CITY OF LA CAÑADA FLINTRIDGE

PLANNING COMMISSION STAFF REPORT

Second Floor Review (DEV-2019-0029)

1035 Fairview Drive (Parcel A adjacent figure)

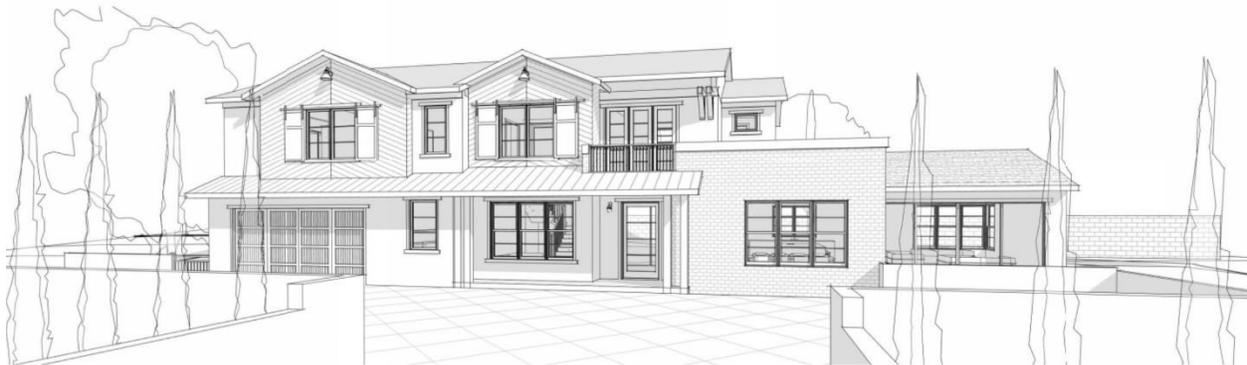
Given the development pattern in the immediate area and frequency of other two-story homes of varied size and design, the introduction of a new traditionally-massed two-story structure, with its tasteful massing and accents, would blend well within the area. The structure is well-articulated and detailed, as evidenced by wall and roof modulation at both floor levels and use of diverse façade materials including wood siding, brick veneer and painted plaster. Though traditionally massed, contemporary accents - angled siding on the front bays and a standing seam metal porch roof - are incorporated into the design.

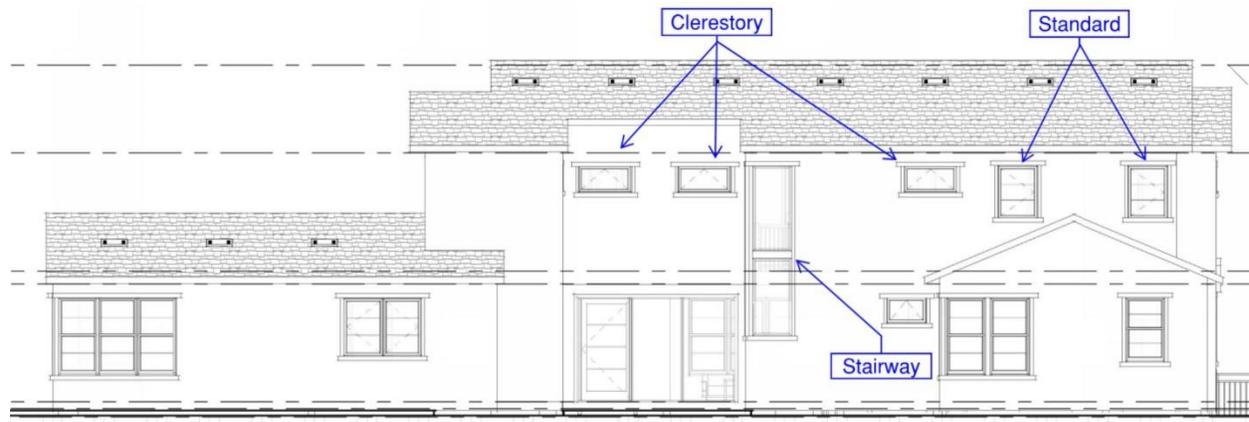
Second-floor fenestration is sensitive to neighboring properties, in particular to the east and west; no windows are proposed on the east elevation while only two small clerestory bedrooms windows are proposed to the west. The lengthier rear elevation would face the rear yards of the properties at 1026 and 1032 Wiladonda Drive, which are developed with a sport court and pool, respectively. Beyond are the respective two-story homes sited approximately 90 feet and 75 feet from the common property line.

Of the six second-floor windows proposed, three are clerestory windows. The tall central window serves the staircase while two standard bathroom windows are to the west. Staff regards this array (shown above) as reasonable and commensurate to the respective interior spaces. A deck is proposed at the front of the east bedroom. While some views to the southeast would be possible, the balcony orients mainly to the front of the subject lot and would be set back almost 70 feet from the east side property line where new landscaping would intervene. It too is regarded as a reasonable project component.
